Date: April 10, 2024  
Our Ref: 30209312

**Subject: Confirmation of Design Compliance with Instrument Conditions (revised)**  
**1580 Fitzgerald Avenue, Courtnay, BC**

**SALVATION ARMY  
 - CV COMMUNITY  
 CHURCH**

<b>Title:</b>	<b>Management Area (Site 19695, CoC, Schedule B)</b>
<b>Project:</b>	1580 AND 1590 FITZGERALD AVE, COURTENAY, B.C.
<b>Client:</b>	THE SALVATION ARMY
<b>Date:</b>	APRIL 2024
<b>ARCADIS</b>	
FIGURE 1

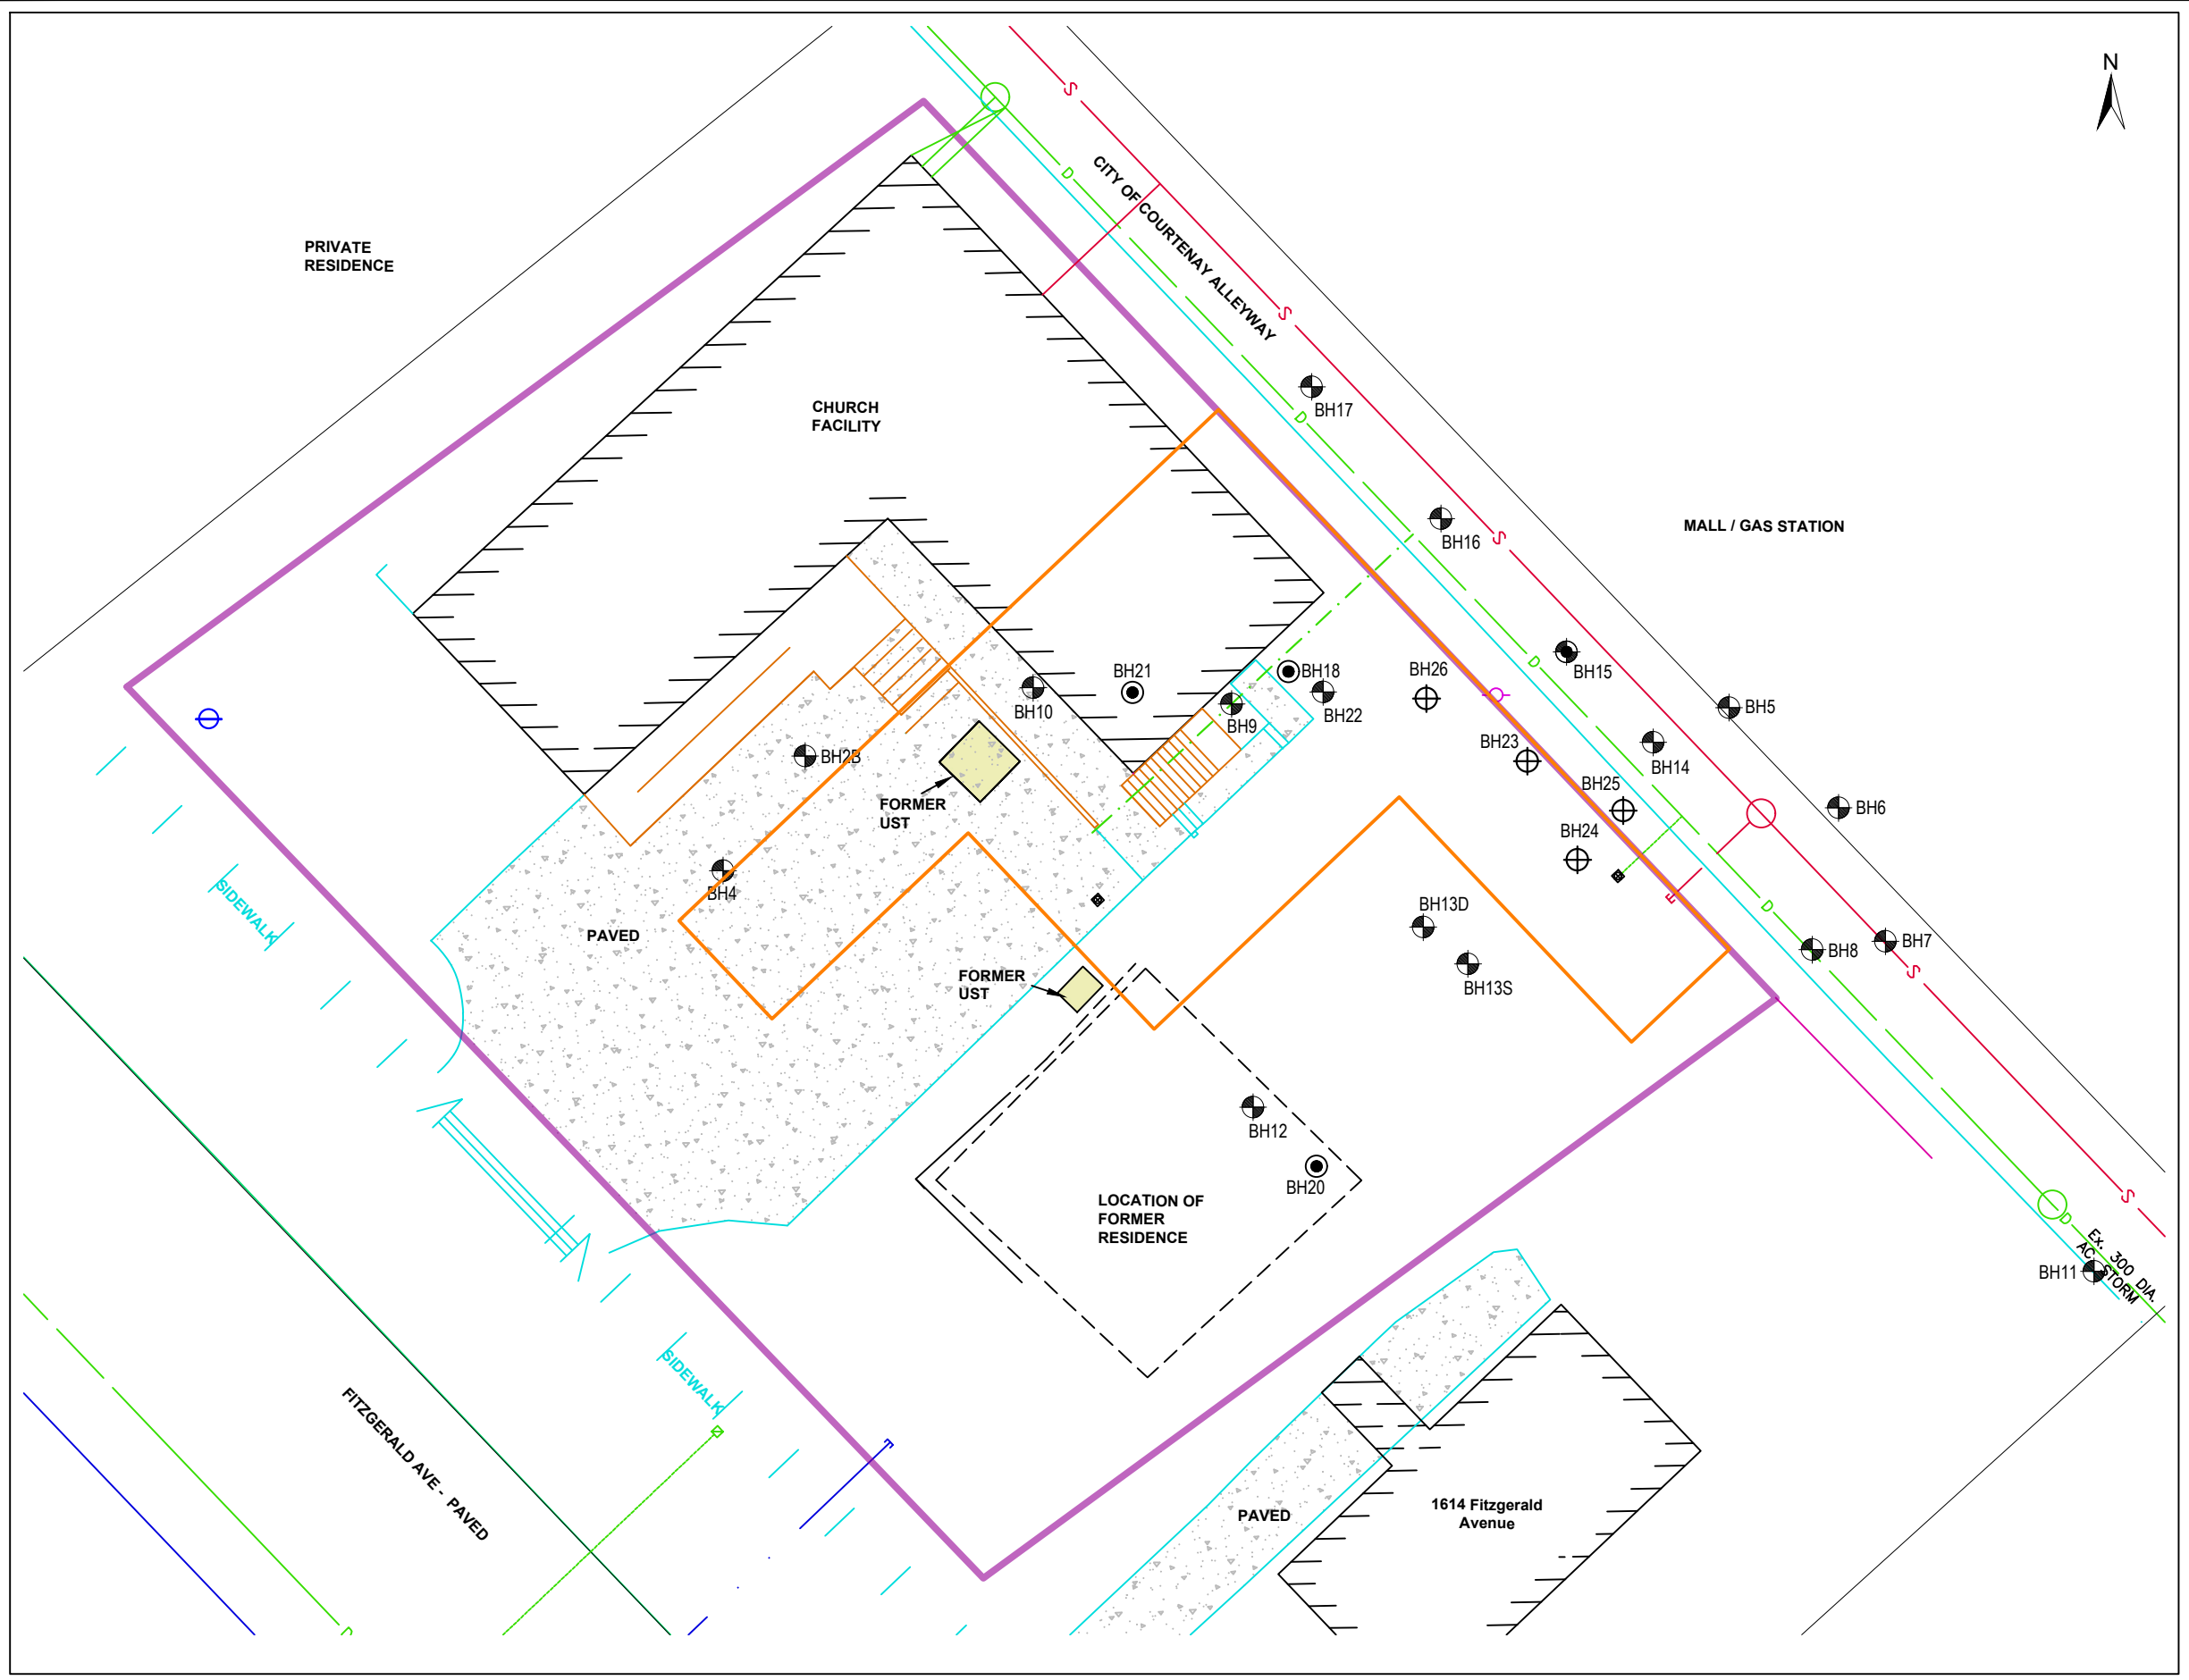
- **Maintaining a Barrier Over the Management Area:** The area of the Site over which contaminated soil remains in place is referred to as the “Management Area” (**Figure 1**). Within the Management Area, a minimum of one of the following conditions must be maintained:
  - The ground surface is covered with an immovable barrier (e.g. asphalt paving or concrete slab) impermeable to human access.
  - A minimum soil thickness of 1 m of soil meeting RL land use standards is in place overlying the contaminated soil at depth below.

On review of the proposed development plan, over 95% of the area of the Management Area will be either paved or covered by the Site building, such that no human exposure to the underlying soil could potentially occur within this portion of the Management Area. Less than 5% of the management area (planting area within the northern boundary of the raised parking area) will contain area for plantings, identified as small shallow rooting shrubs. The elevation of grade at this portion of the Site will be over 2m above grade existing at the time of investigation & risk assessment, and likely separated from grade by concrete structure. Accordingly, the proposed development is compliant with this condition.

- **No Deep Rooting Plants within the Management Area:** Within the Management Area, no plants with roots which will exceed 1 m in depth from ground surface, should be planted. On review of the proposed development plan, over 95% of the area of the Management Area will be either paved or covered by the

Site building. Less than 5% of the management area (planting area within the northern boundary of the raised parking area) will contain area for plantings, identified as small shallow rooting shrubs. Accordingly, the proposed development is compliant with this condition.

**SITE PLAN**

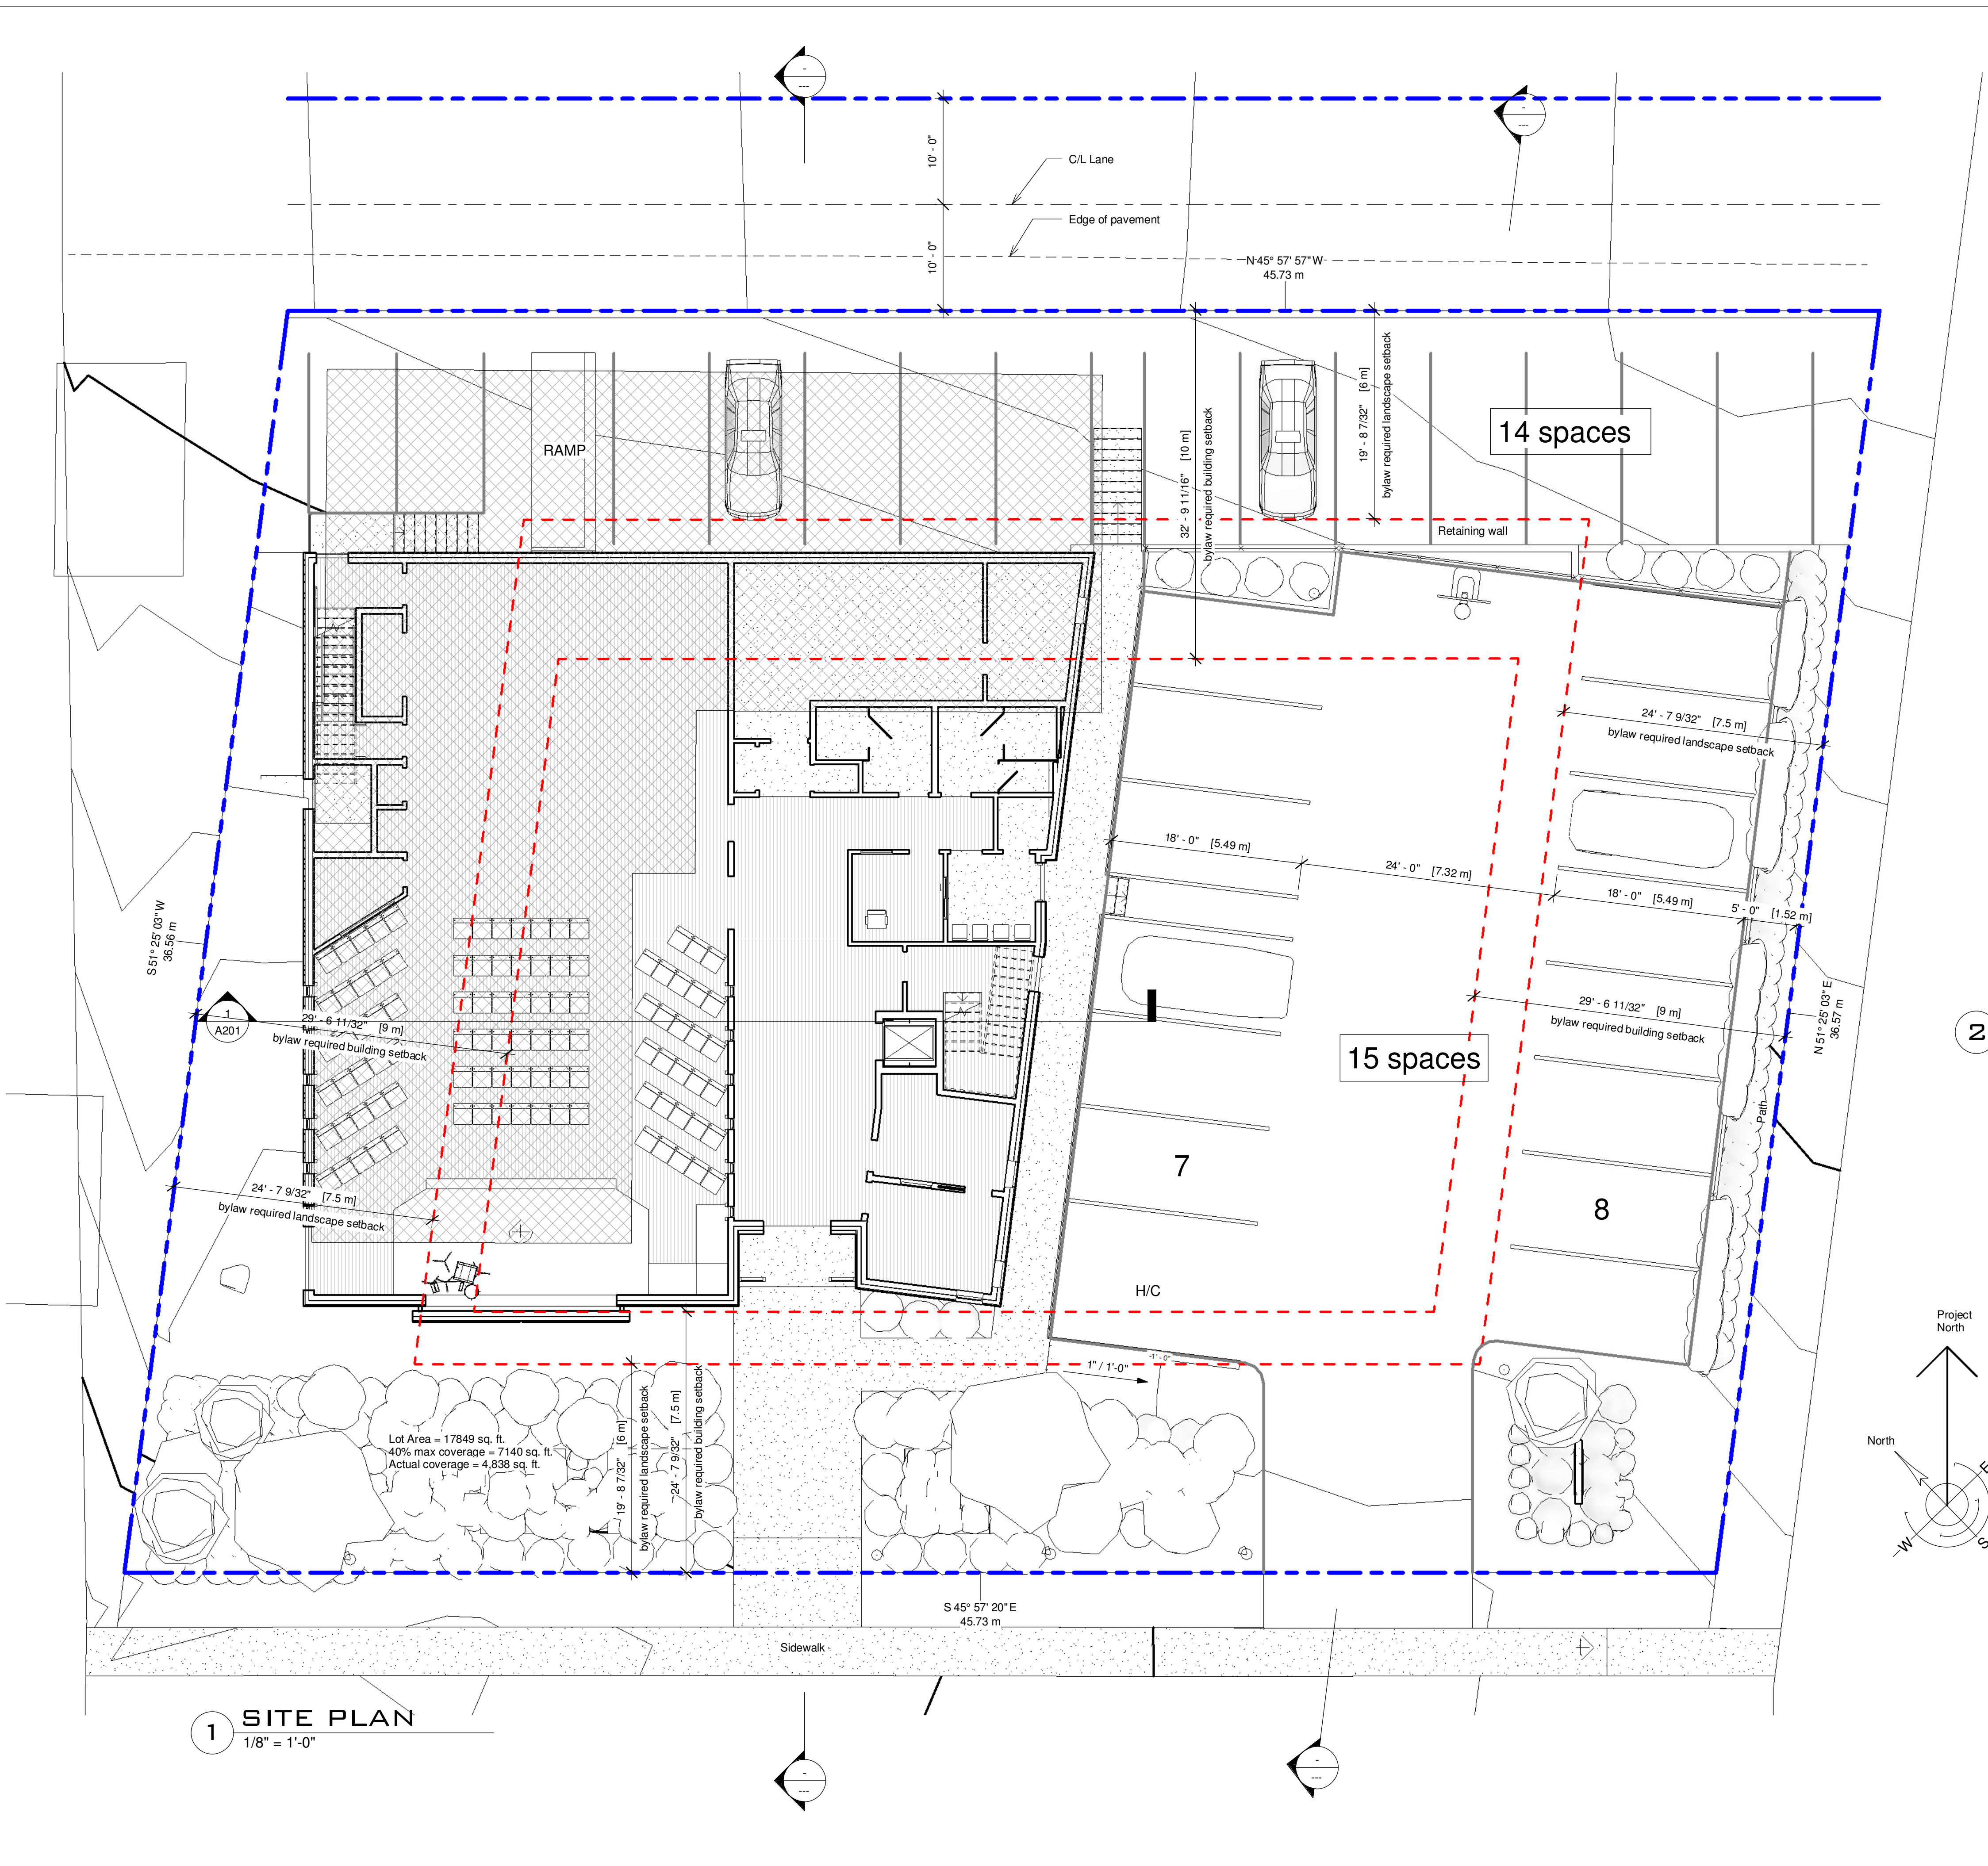
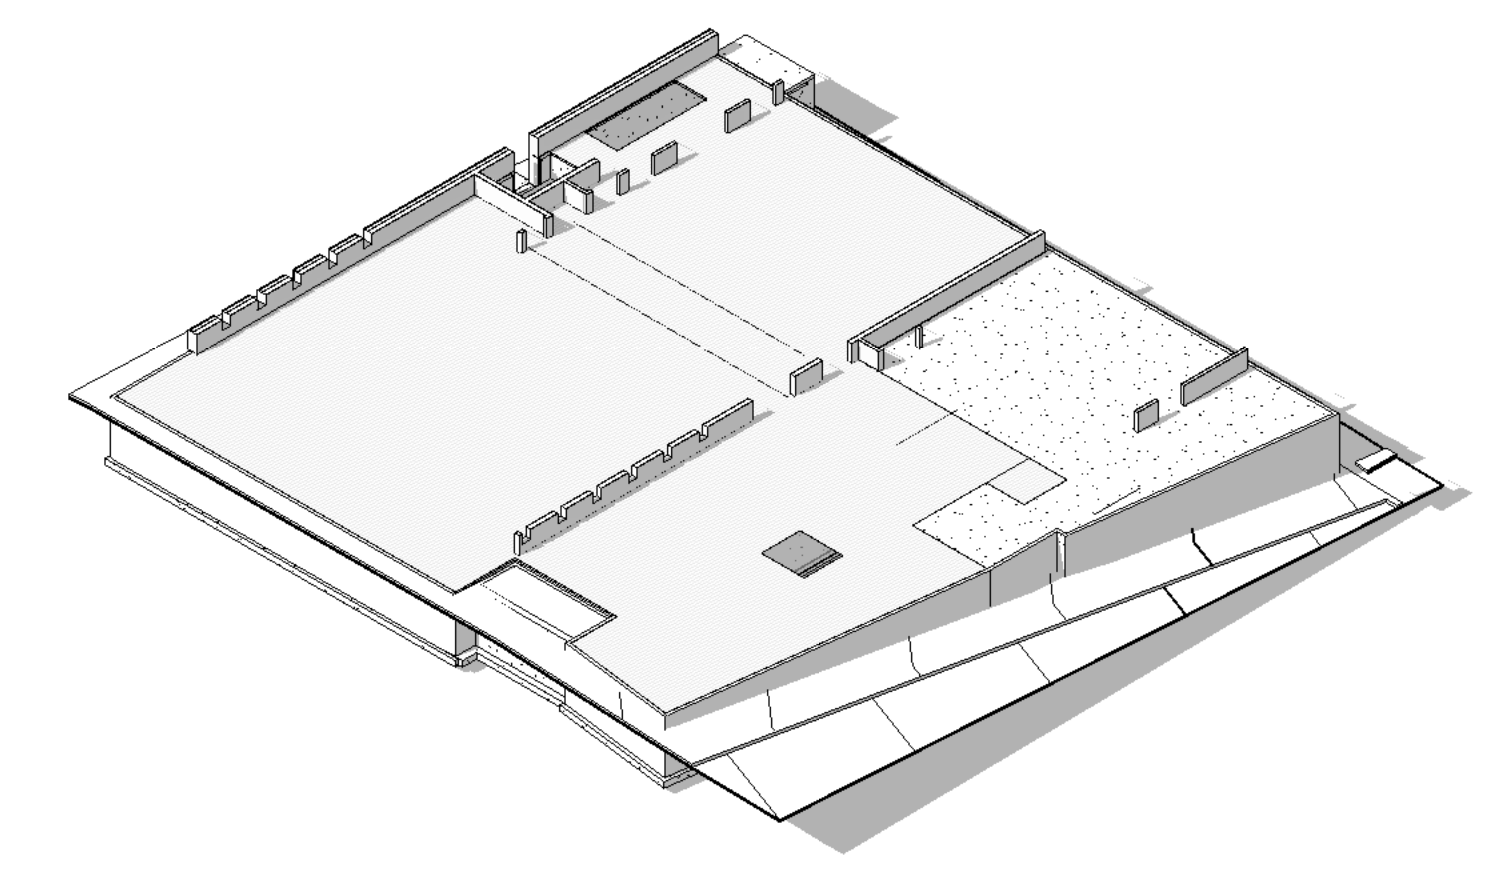
- a new building on the western half of the Site,
- a row of paved parking spaces along the northern extent of the property abutting the laneway,
- a paved parking area on the eastern half of the Site, with perimeter planting areas along the north and east perimeter, and
- a planted area along the southern extent of the property abutting the sidewalk along Fitzgerald Avenue, with the exception of a walkway (accessing the Site building) and a driveway (accessing the eastern parking area).

A review of the elevations for the above-noted developmental areas identified that the northern parking area was consistent or slightly above the elevation of the laneway, while the eastern parking area will be at the elevation or slightly below that of Fitzgerald Avenue, and just over 2 m above the elevation of the laneway.
